STAFF REPORT
COMMUNITY DEVELOPMENT DEPARTMENT

HEARING DATE: 08/27/2024
TO: Mayor & City Council
FROM: Nick Napoli, Associate Planner
208-884-5533
SUBJECT: Pebblebrook Subdivision
FP-2024-0014
LOCATION: The site is located at 5725 N. Meridian Road, in the NE ¼ of Section 25, T.4N., R.1W. (Parcels #S0425142030 & S0425141990)

Final Plat consisting of 52 single-family detached and six (6) common lots on approximately 13.94 acres of land in the R-8 zoning district by Hayden Homes, LLC.

B. Final Plat (dated: 06/27/24)

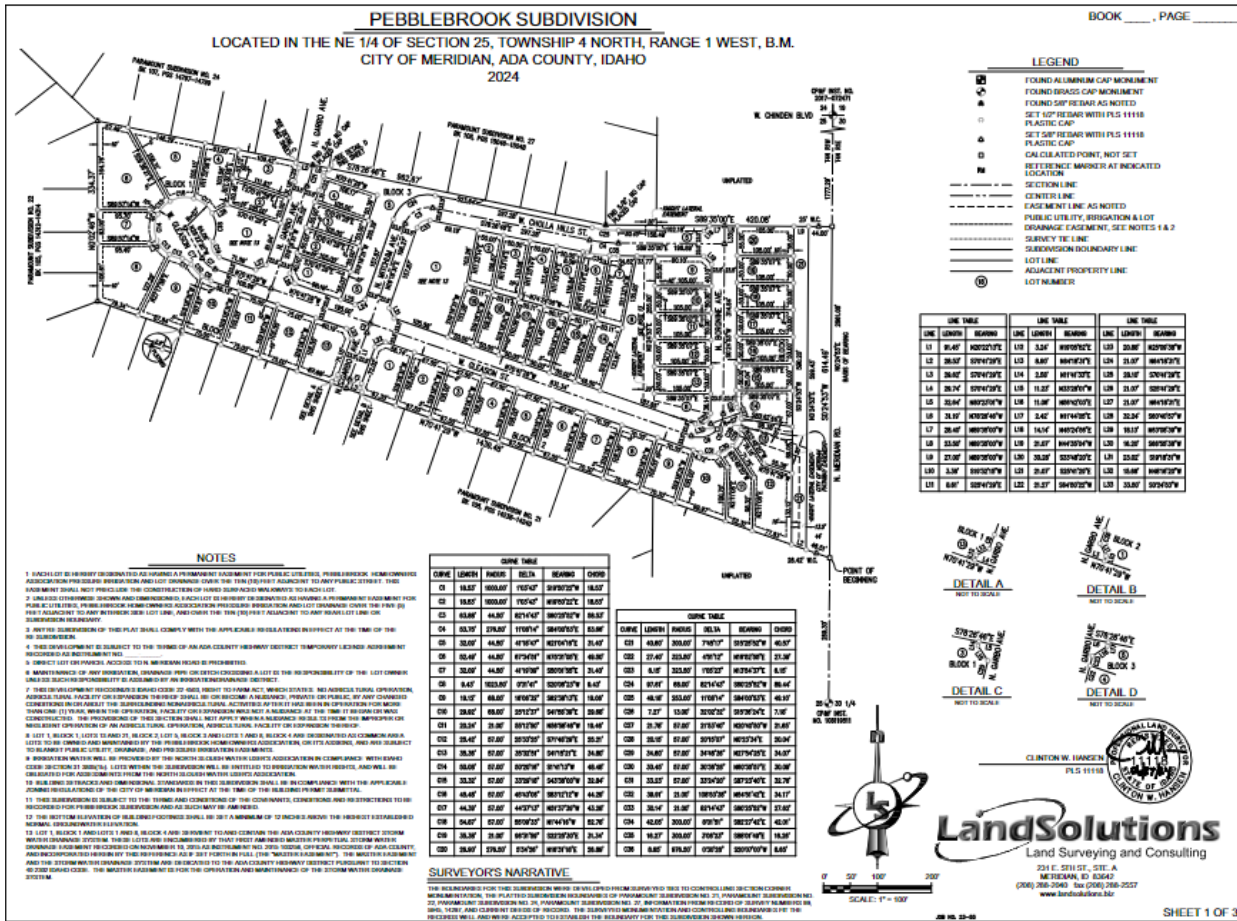
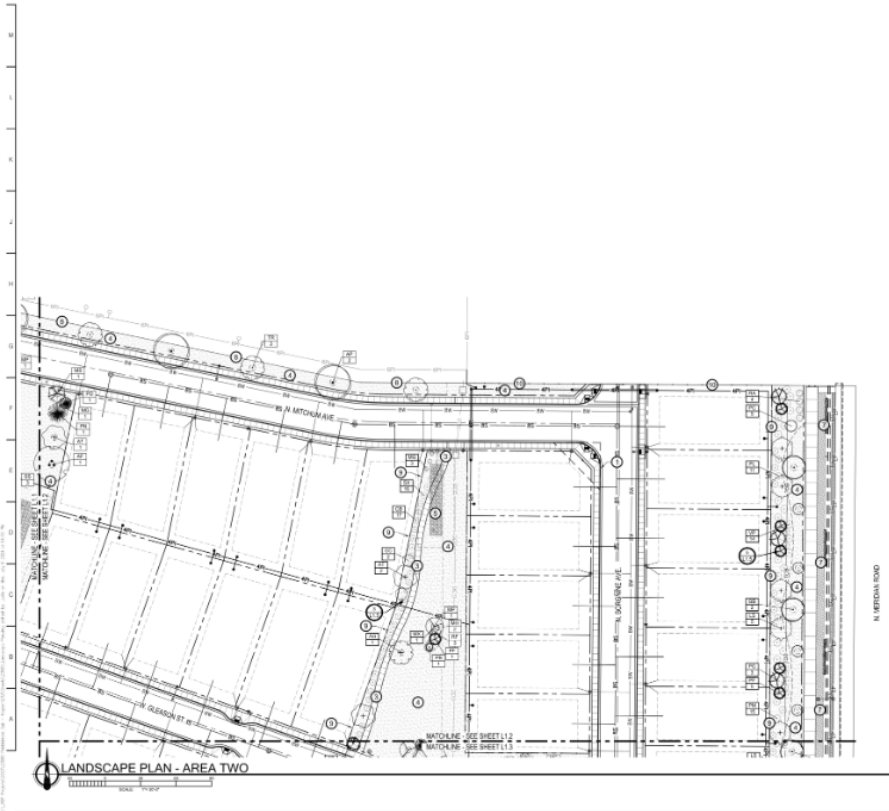
- a. Note #4: Include the recorded instrument number for the ACHD license agreement.
A copy of the revised plat shall be submitted with the final plat for City Engineer signature.

LANDSCAPE PLAN - AREA TWO

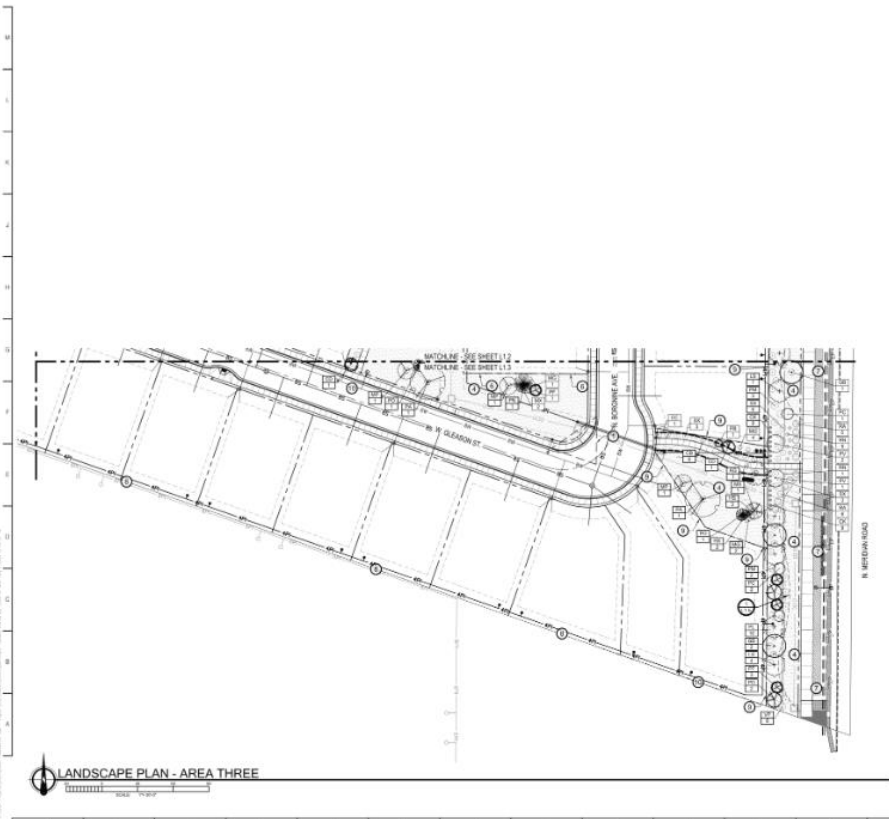
5. The landscape plan prepared by Jensen Belts, dated 07/08/2024, included in Section V.C, shall be revised as follows:
 - a. Provide a fencing exhibit to show the different types of fencing abutting pathways and common open space lots.
A copy of the revised plat shall be submitted with the final plat for City Engineer signature.
